# W8 Hull and machinery steel castings

(1978)  
(Rev.1  
July 2002)  
(Rev.2  
May 2004)  
(Rev.3  
Mar 2022)

Fig. 1: Specimen positions relative to the test block in accordance with ISO 4990:2015\*

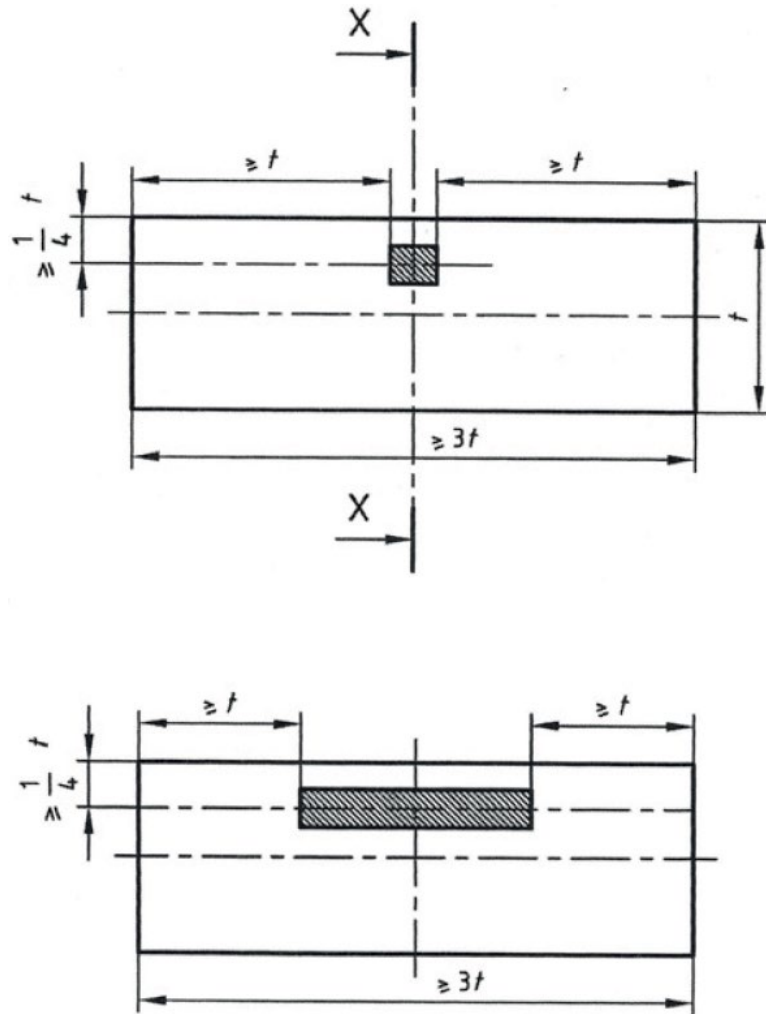
W8.6.3 For large thickness castings other than stern tube, stern frame, anchor and rudder horn,  $t_s$  normally need not to exceed 150 mm. Length and width of the test block is normally to be at least three times  $t_s$ , unless otherwise agreed with the Class Society, as shown in Figure 1. (Note that longer or wider test blocks may be necessary in order to accommodate the required test specimens.)

6.4 For test blocks with thickness  $\leq 56$  mm, the longitudinal axis of the test specimens is to be located at  $\geq 14$  mm from the surface in the thickness direction. For test blocks with thickness  $> 56$  mm, the longitudinal axis of the test specimens is to be located at  $\geq \frac{1}{4} t_s$  from the surface. Test specimens shall be taken in such a way that no part of the gauge length is machined from material closer than  $t_s$  to any of the other surfaces. For impact testing, this requirement shall apply to the complete test specimen - refer to Figure 1 for location of test specimens in relation to the test block.

Fig. 2: Example 2: test block gated to stern tube casting

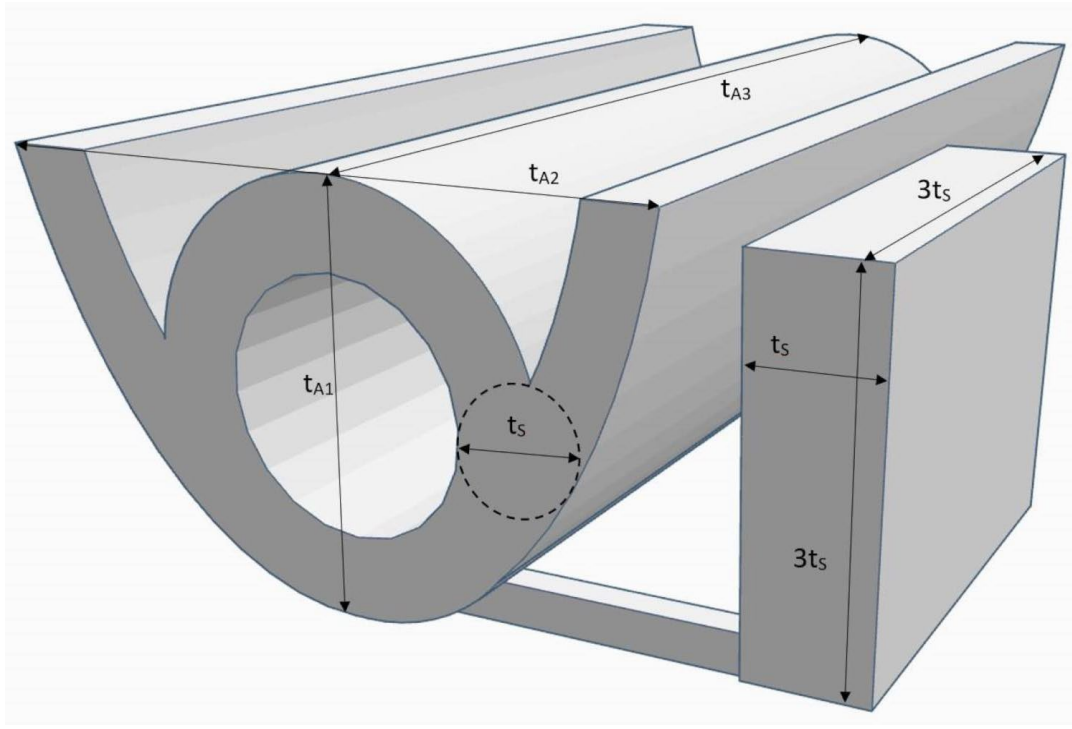
Example 2: For a stern tube casting with ruling section  $t_s = 170$  mm and width/height/length  $t_{A1}/t_{A2}/t_{A3} = 1000/600/1800$  mm, the required test block size would typically be 170 x 510 x 510 mm (that is:  $t_s \times 3t_s \times 3t_s$ ) see Figure 2.  
(end of guidance)
